## City of Albuquerque

RE: TARGET ADDITION - PLAZA AT PASEO (C13-D21). CONCEPTUAL GRADING AND DRAINAGE PLAN FOF SITE DEVELOPMENT PLAN FOR BUILDING PERMIT APPROVAL. ENGINEER'S STAMP DATED SEPTEMBER 17, 1998. GRADING AND DRAINAGE PLAN FOR BUILDING PERMIT APPROVAL. ENGINEER'S STAMP DATED OCTOBER 2, 1998. CLARIFICATION LETTER OF OCTOBER 19, 1998.

Re: Target Addition - Plaza @ Paseo (C13/D21)

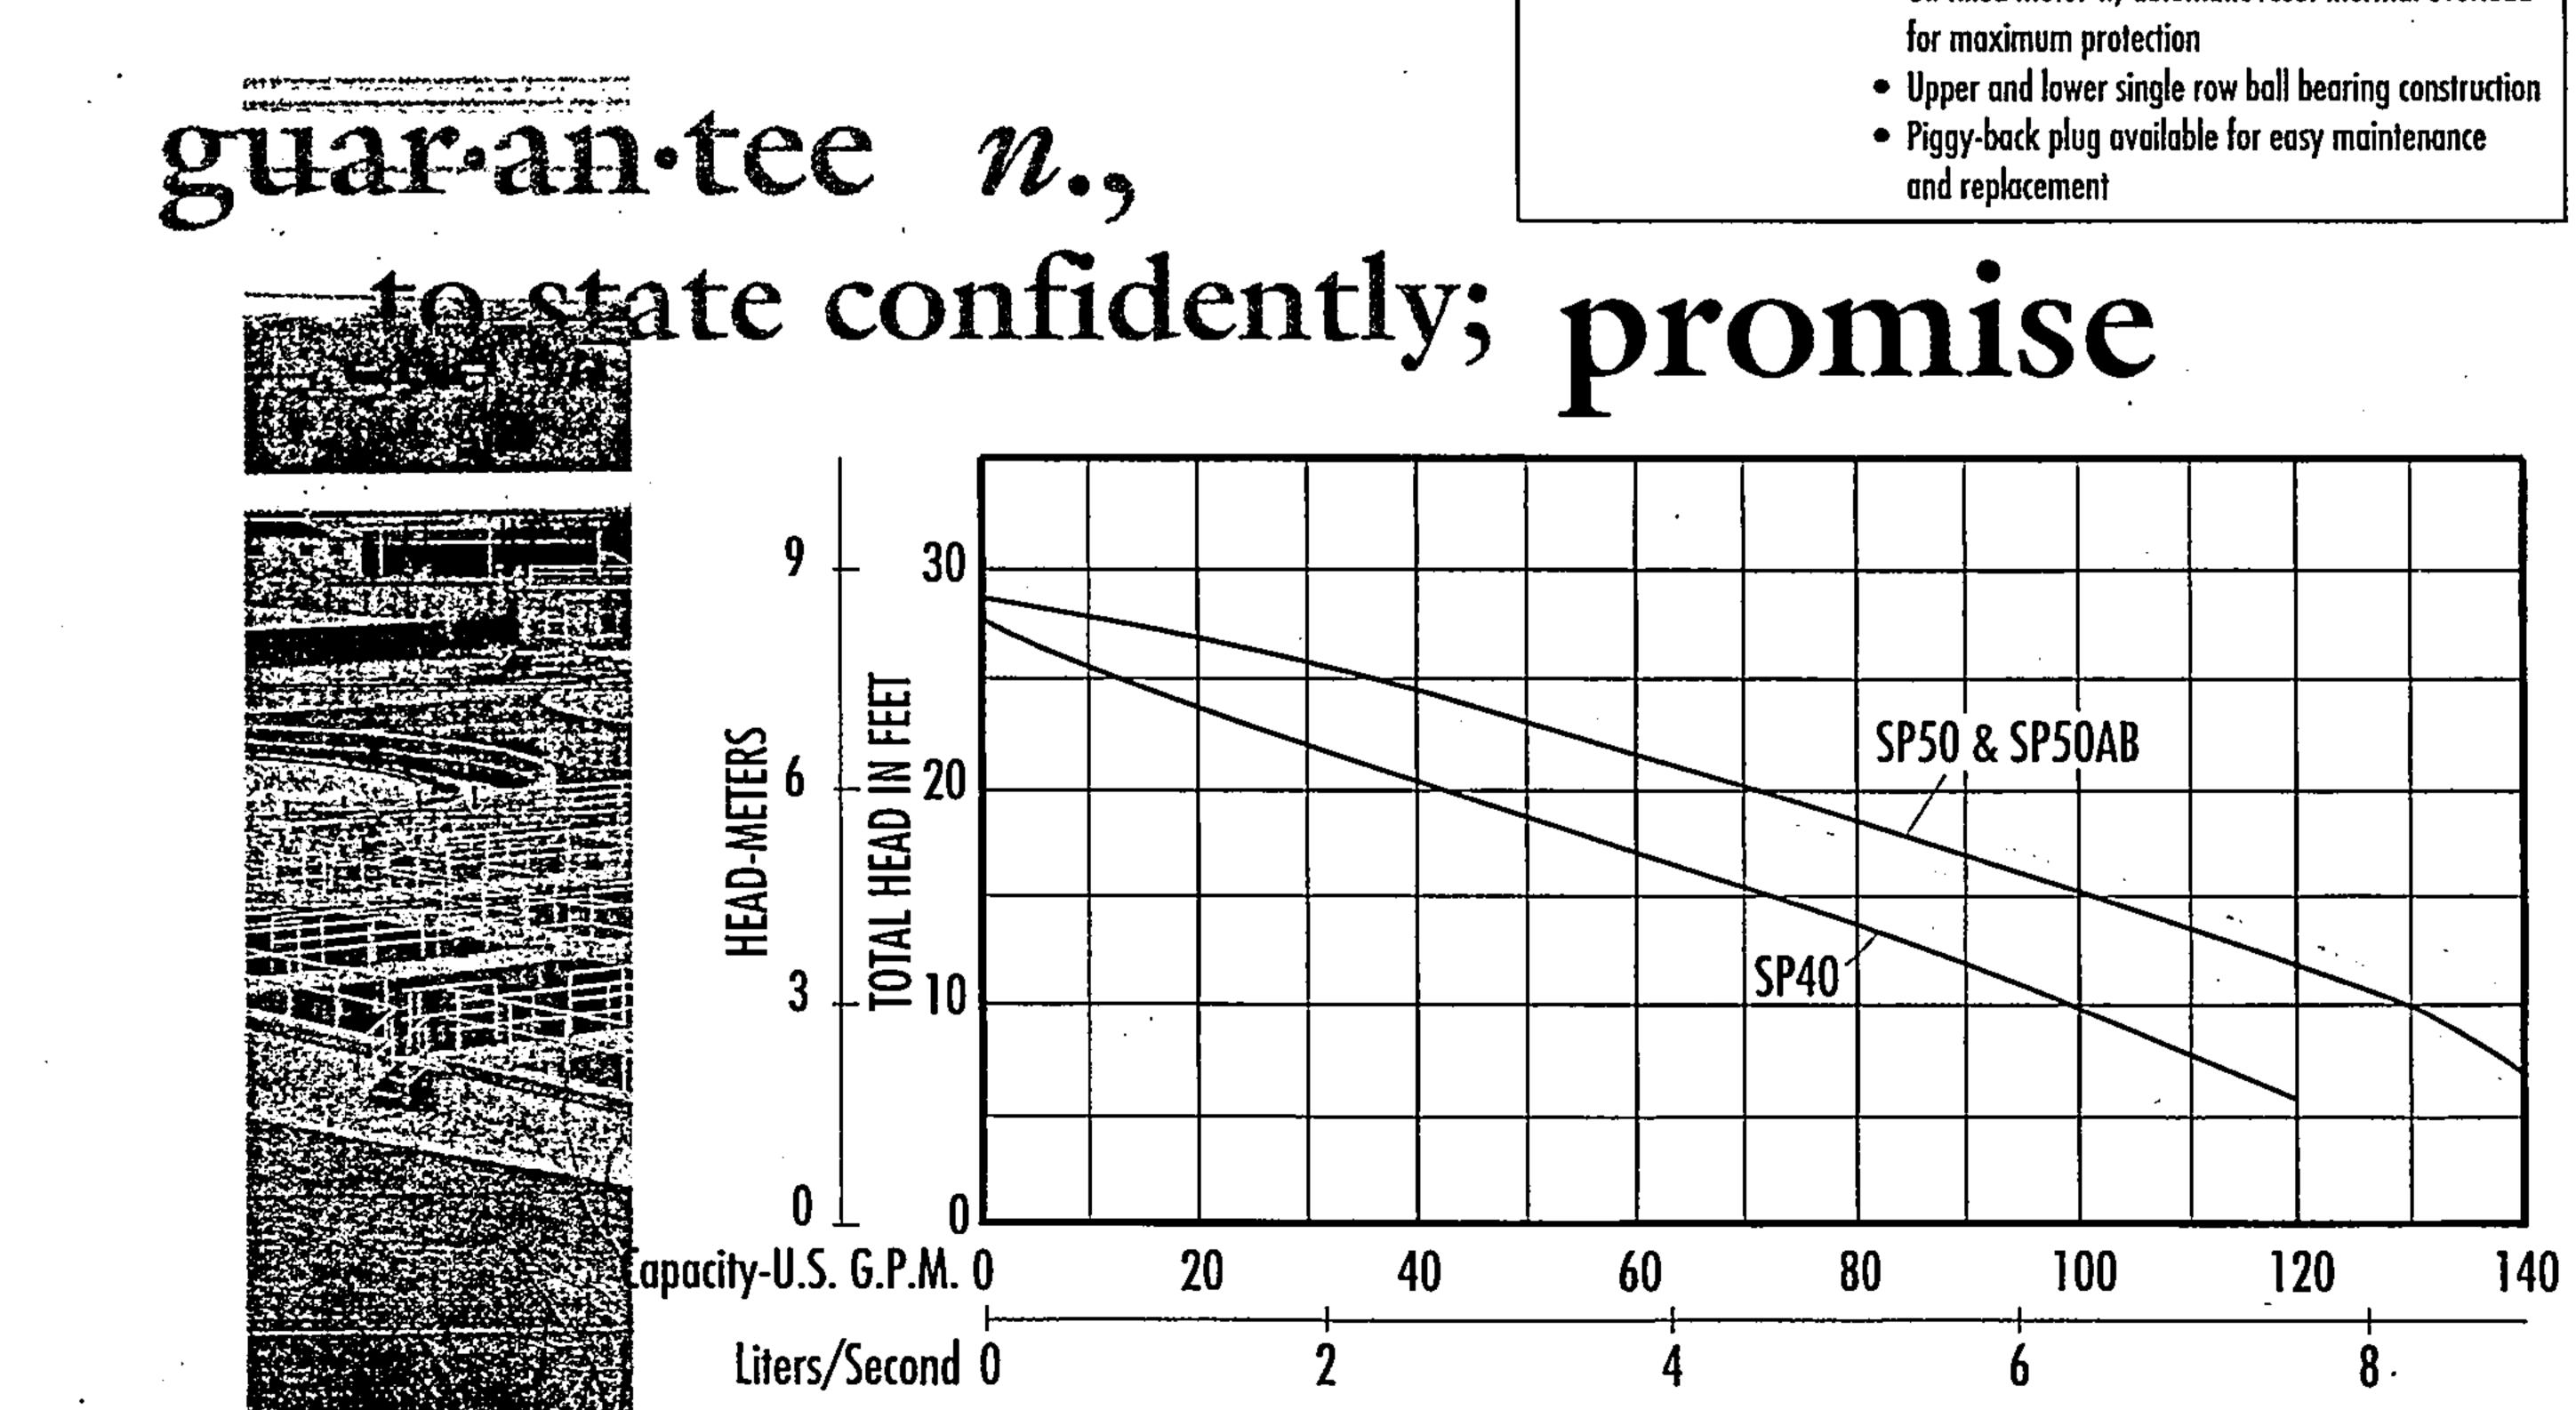
Please furnish basic data and narative information as to how this addition affects the master drainage plan and the critera for the sump pump installation.

Attached, please find a copy of the approved Master Plan. The projects highlighted were performed by our firm. During the course of our involvement, we have verified that all downstream improvements are in place and functioning per the Master Plan.

From the Master Plan and the topography survey, it can be seen that this proposed addition does not increase the runoff nor significantly change the drainage pattern. We are replacing impervious area with other impervious area. The flow rate to thee sump pump will be 0.2 cfs or 111 gpm. Per the attached performance curve, you can see that the sump pump is adequate. With this response, we respectfully request Building Permit approval for the plan with engineers date 10/2/98. We are not submitting a new plan at this time.
